Building Completion Report.

I beg to report, the building work on plot No. 51 Sheet

A 20 Mrp Quarter owned by Mr. Pehlaj Das Hundar.

ON PLOT NO 51 = A 20

PLAN OF PROPOSED HOUSE

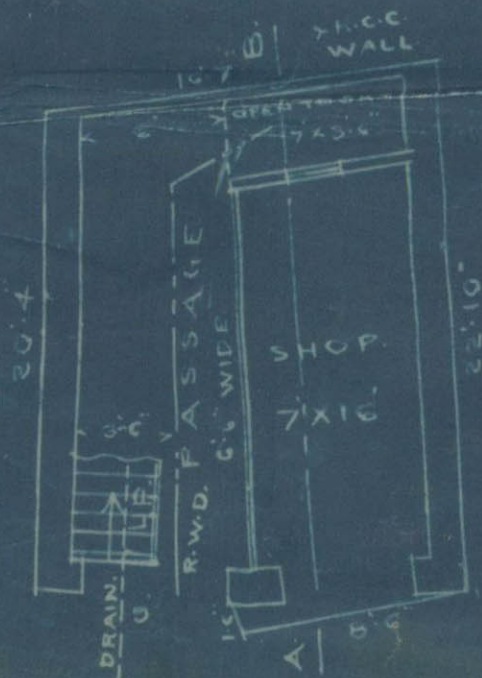
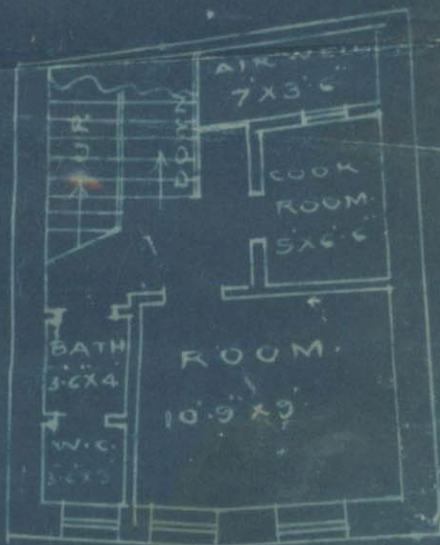
~~he is~~ they are deviating from the approved plan, They are erecting
new walls on the 1st & 2nd floor of bricks
only 6" thick, instead of 8 R.C.C. walls.

submitted, with plan &
report. the owner wants
a pucca wall 1'-6" instead
of R.C. wall. I don't see
any obj. to allow him
to do so. P.B.

Instructions are therefore given to ~~him~~ them to at once stop the work and
make the building in conformity to the approved plan, or steps will be taken
under the Act.

no obj
9/2 SB
